Informal document **GRVA-05-33**
5th GRVA, 10-14 February 2020
Agenda item 5 (a)

Draft UN Regulation on Cyber Security (CS)

Comments to document GRVA-05-05 from the experts of OICA and CLEPA

2.1 Transition time for existing architectures

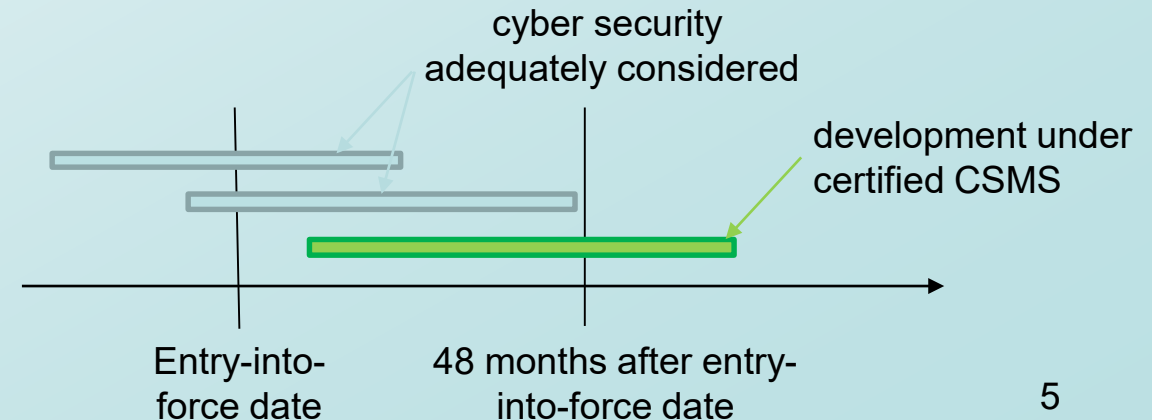
However, if the vehicle manufacturer can demonstrate that the vehicle type could not be developed in compliance with the CSMS, because it was ~~partly or~~ fully developed **before latest until [48 months]** after entry into force of this Regulation, then the vehicle manufacturer shall demonstrate that cyber security was adequately considered during the development phase.

- Transitional provision required for **existing vehicle architectures** and for such which are already under development **cannot be retrospectively brought into compliance** with the requirements of the new regulation (**formally and technically**).
- Deletion of “partly or” and “before” and the introduction of “latest until” to clarify that the **development has to be finished 48 months after the entry into force of the regulation**.
- The **development** of automotive **architectures** takes **typically 4-6 years**.
- Architecture will be used across various carlines.
- Transition time required for **manufacturers** and **suppliers** to **adopt their technology** and roll-out plans accordingly.

7.3.1. The manufacturer shall have a valid Certificate of Compliance for the Cyber Security Management System relevant to the vehicle type being approved.
